MANHEIM TOWNSHIP SCHOOL DISTRICT - NEW MAINTENANCE FACILITY

ADDENDUM NO. 1

The Project Manual and Drawings for the Manheim Township School District's New Maintenance Facility Project, forming a part thereof, are modified as follows:

SECTION 210000 - FIRE PROTECTION

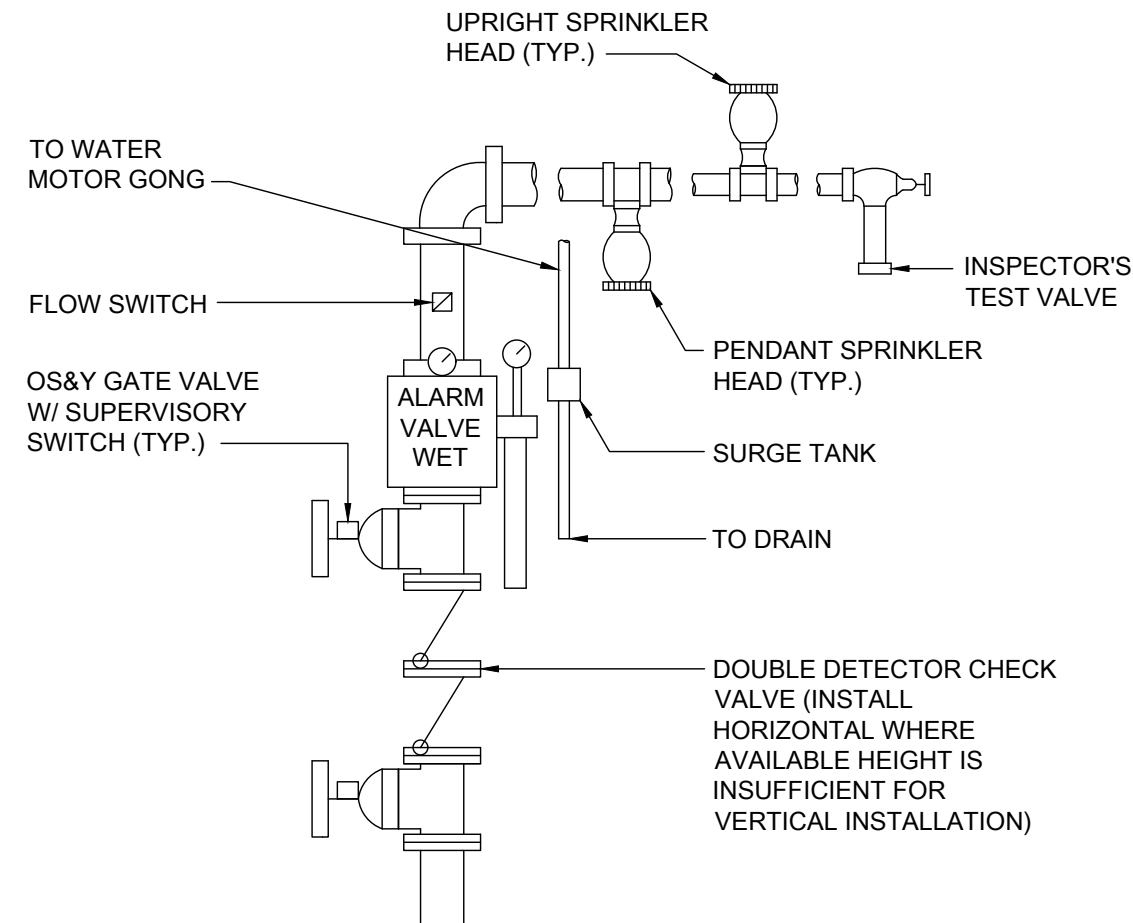
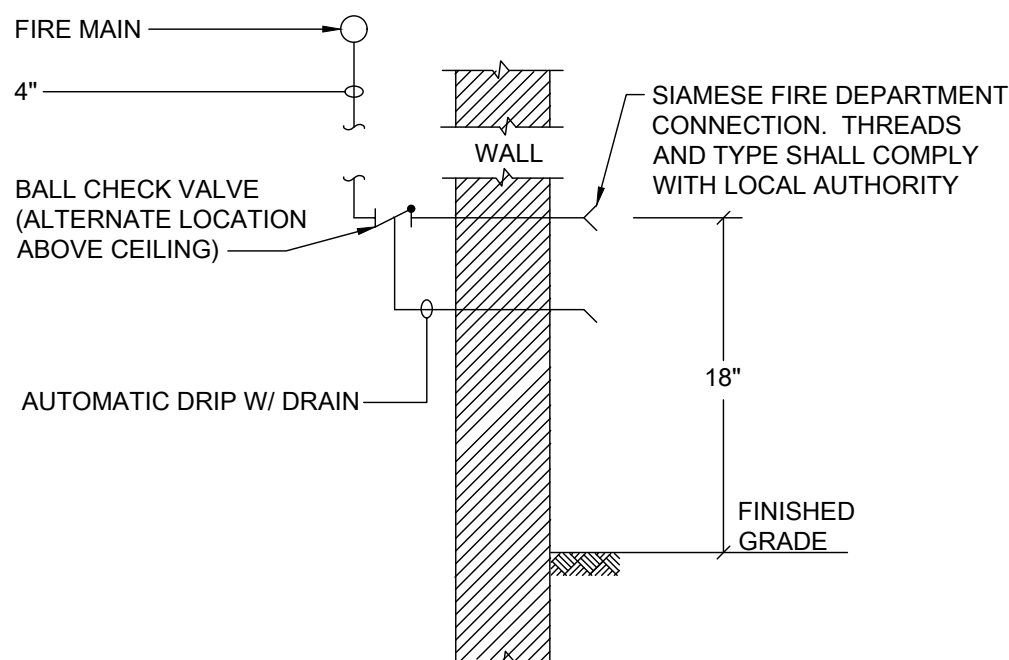
- 1-12. The Plumbing Contractor shall be responsible for the complete design, engineering, permitting support, and installation of the automatic fire sprinkler system. The sprinkler system shall be provided as a delegated design, prepared, signed, and sealed by a licensed Fire Protection Engineer or other design professional authorized by the Authority Having Jurisdiction (AHJ). The sprinkler system design shall be submitted as a deferred submittal for review and approval by the Township Code Officials prior to fabrication or installation. A performance specification and performance drawings defining the design criteria are included as attachments to this Addendum and shall serve as the basis for the delegated design.

- SPRINKLER SYSTEM DELEGATED DESIGN:
- PROVIDE CHROME PLATED STANDARD RESPONSE PENDANT HEADS IN CENTER OF CEILING TILES OR BRASS UPRIGHT HEADS IN AREAS WITHOUT CEILINGS. COORDINATE HEAD TYPES AND TEMPERATURE RATINGS WITH OWNER FOR FUNCTIONAL REQUIREMENTS OF EACH SPACE.

- PROVIDE DRAIN VALVES AND INSPECTOR'S TEST AND SIGHT GLASS FOR TESTING.
 - PROVIDE SIAMESE FIRE DEPARTMENT CONNECTION ON ADDRESS SIDE OF THE BUILDING WITH HOSE CONNECTION TYPE AS REQUIRED BY THE LOCAL AUTHORITY.

- PROVIDE ALARM VALVES FOR EACH ZONE WITH A MAXIMUM COVERAGE AREA OF 52,000 SQUARE FEET (FOR LIGHT HAZARD OR ORDINARY HAZARD GROUP 1) OR AS REQUIRED BY NFPA 13 AND IBC.

- OBTAIN HYDRANT FLOW TEST DATA AND PERFORM HYDRAULIC CALCULATIONS.
 - PROVIDE DRAWINGS AND CALCULATIONS SEALED BY THE REGISTERED PROFESSIONAL ENGINEER IN RESPONSIBLE CHARGE AND ISSUE TO AUTHORITY TO OBTAIN PERMIT, INCLUDING PERMIT FEES.

- PROVIDE WET PIPE SPRINKLER SYSTEM FOR ALL AREAS OF THE BUILDING ACCORDING TO NFPA 13 REQUIREMENTS FOR ORDINARY HAZARD GROUP 1.
 - PROVIDE DRY PIPE SYSTEMS FOR ATTICS, FREEZERS, AND OTHER UNHEATED SPACES ACCORDING TO NFPA 13.
